BULLETINS: SERVICE AND TECHNICAL
PARTS, WARRANTY, ORGANIZATION.

**BULLETINS: SERVICE AND TECHNICAL
PARTS, WARRANTY, ORGANIZATION.**

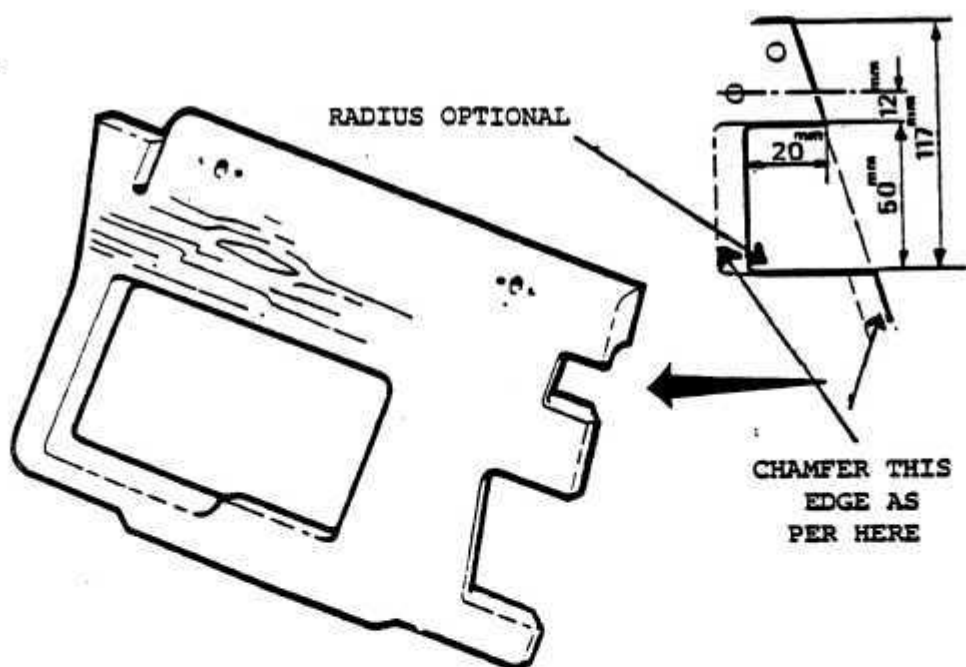
From V.I.N. 2309, a recess has been cut out of the right rear bulkhead panel to accommodate the wiring harness. See the diagram below.

This modification may also be made on earlier vehicles to improve harness routing.

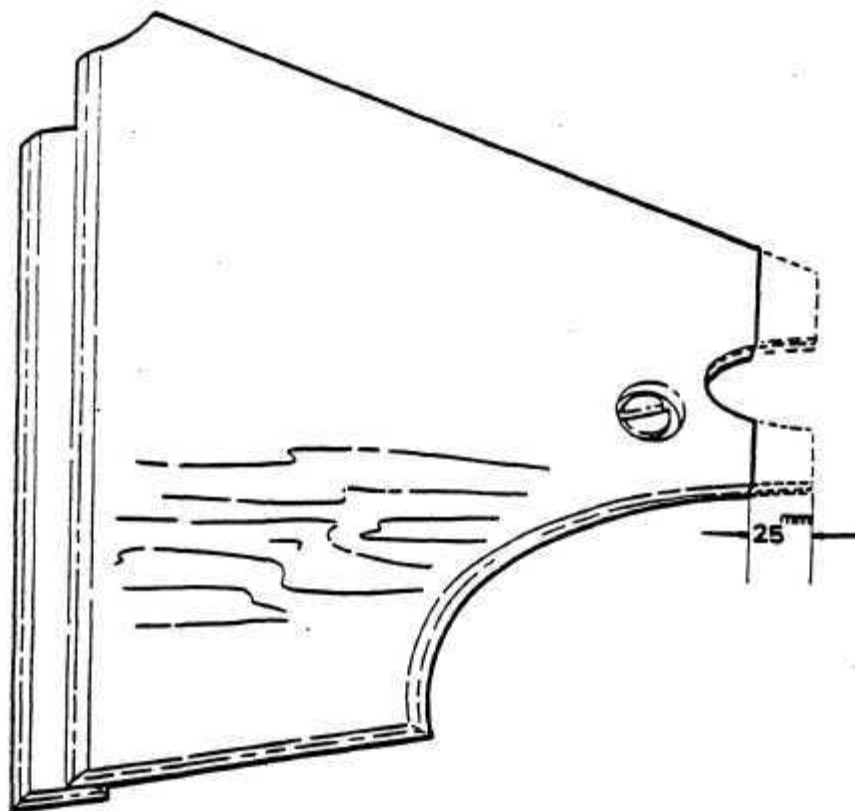
From V.I.N. 2309, to facilitate removal of the rear parcel shelf boards, 25mm has been cut from the top edge of both boards. See the diagram below.

This modification may also be made on earlier vehicles.

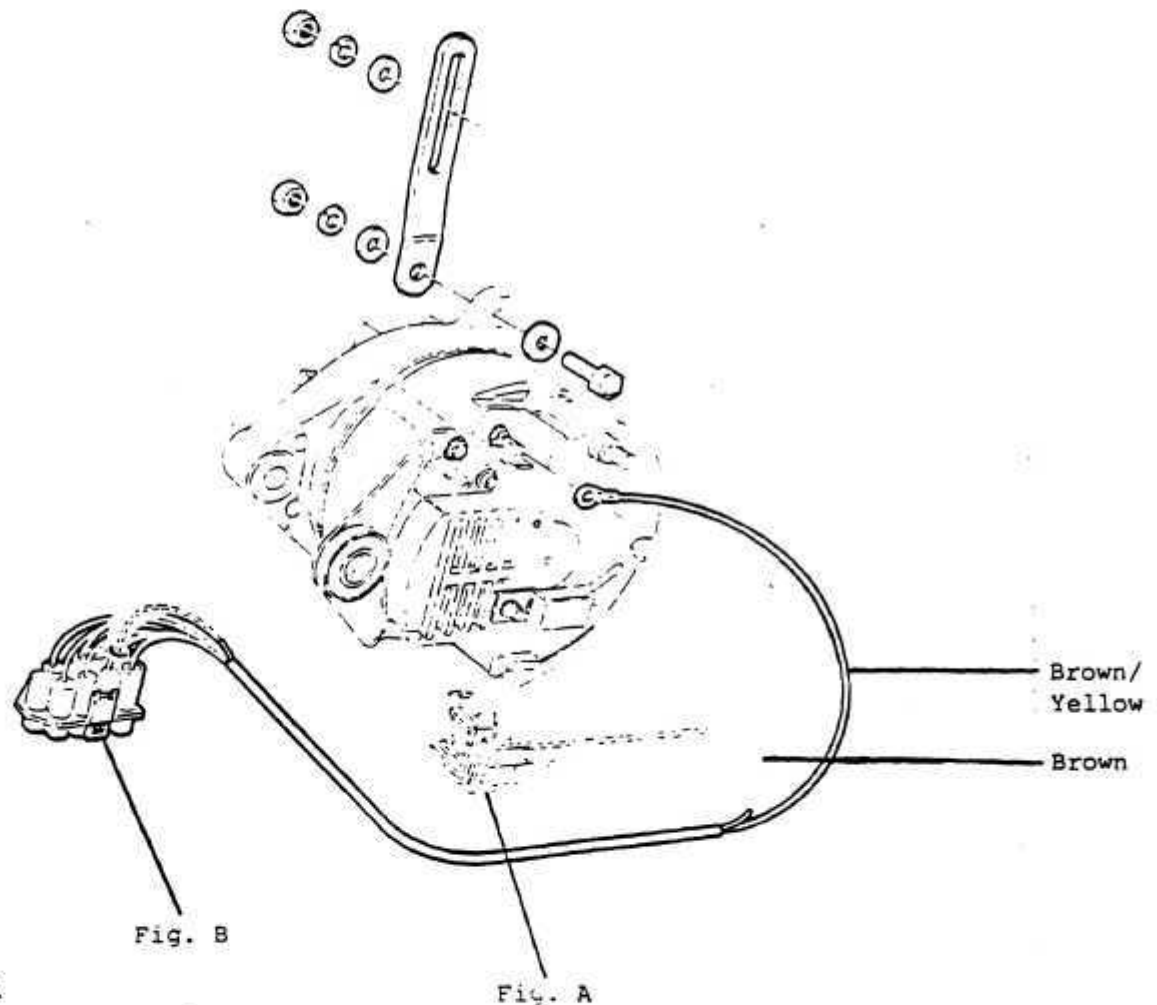
If alternator replacement becomes necessary on vehicles prior to V.I.N. 4539, the alternator mounting and wiring must be modified according to the attached instructions.

1. Disconnect battery.
2. Remove existing alternator and bracket.
3. Cut off original alternator plug. (See Figure A.)
4. Remove harness sheathing back to 1 inch before oil pressure sender break out to exposing brown wire and brown/yellow tracer wire.

10. Fit new eyelet to brown/yellow wire.
11. Re-tape main harness with electrical tape.
12. Fit the Motorola Type 90A Alternator using the modified adjusting bracket Part No. 110102 which is fitted in reverse position to the original bracket i.e., adjusting or slide portion to be bolted to the engine crankcase, fixed end of the bracket to the alternator end cover.

Fig. 5

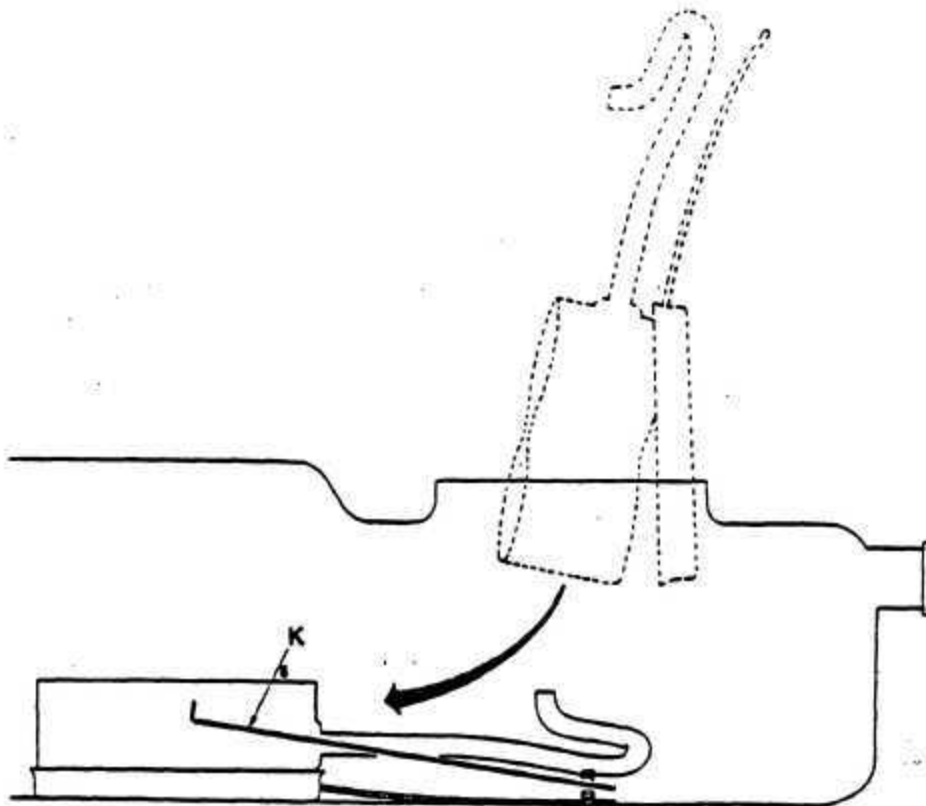
A modified new baffle Part No. 110155 for the fuel tank has been introduced as of V.I.N. 4782.

5. Fit and position outer spring K under fuel flex feed hose (on baffle) and onto stud on base of fuel tank. (Do not locate spring on baffle edge at this stage.)
6. Loosely fasten baffle and (2) two baffle retainer springs to stud in fuel tank base.
7. Locate hooked legs of retainer spring outer to rim of baffle.
8. Finally tighten M6 nut to secure baffle and retainer springs to fuel tank stud L (Do not over-tighten.)
9. Connect fuel feed pipe to pump and fit pump assembly to tank.

Figure 1
OLD CONDITION

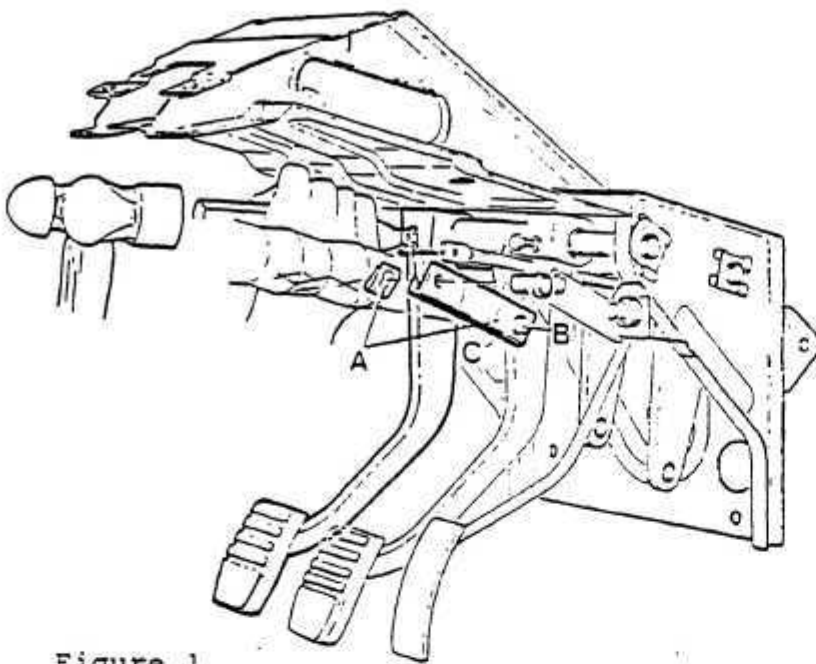
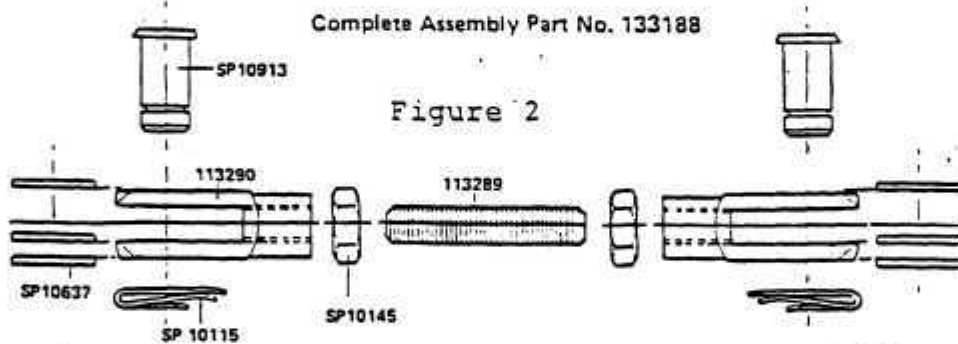
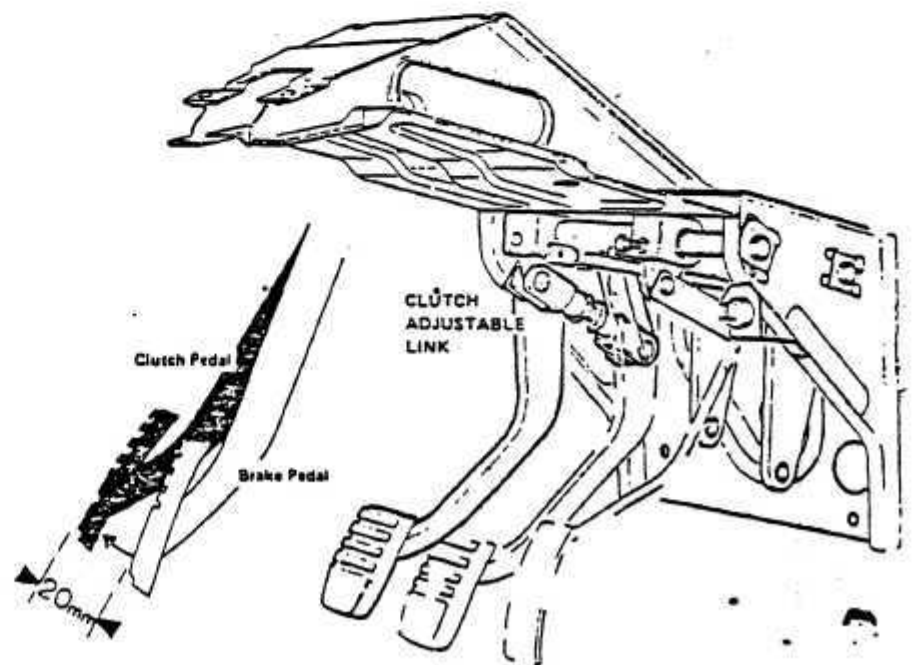
The clutch pedal stop bolt and weld nuts must be removed to permit the pedal to be raised. To carry out this operation, the following procedure should be observed (Figure 1).

D) Using a hammer and sharp chisel carefully shear off the 10 mm clutch stop nuts welded on both sides of the pedal box (Figure 1).

E) Assemble the adjustable clutch link (Figure 2) (Part Number 133188). Adjust both clevis ends evenly on the threaded rod so as when the link is secured the clutch pedal is 20 mm (3/4") higher than the brake pedal (Figure 3).

FIGURE 2

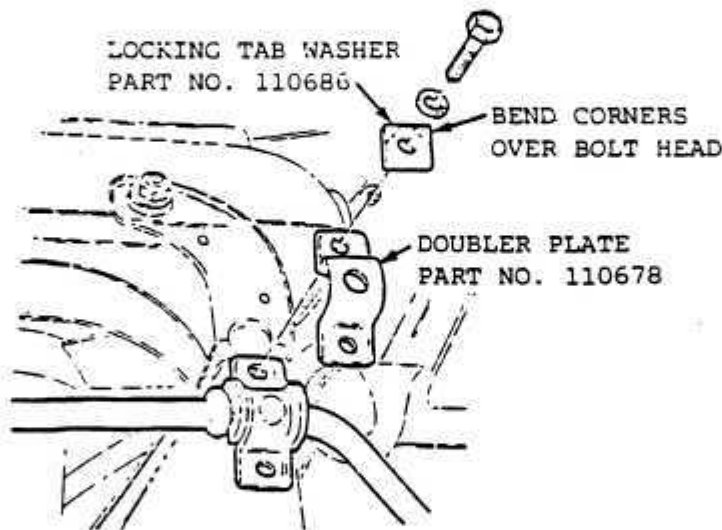
REPAIR PROCEDURE - STABILIZER BAR MOUNTING BRACKET

3. Install reinforcement bracket Part No. 110678 over the existing bracket.
4. Install lock tab, lock washer and bolt as shown in Figure 2 (using existing lock washer and bolts).
5. Torque bolts to 35NM (26 ft/lbs).
6. Bend locking tabs as per Figure 2.
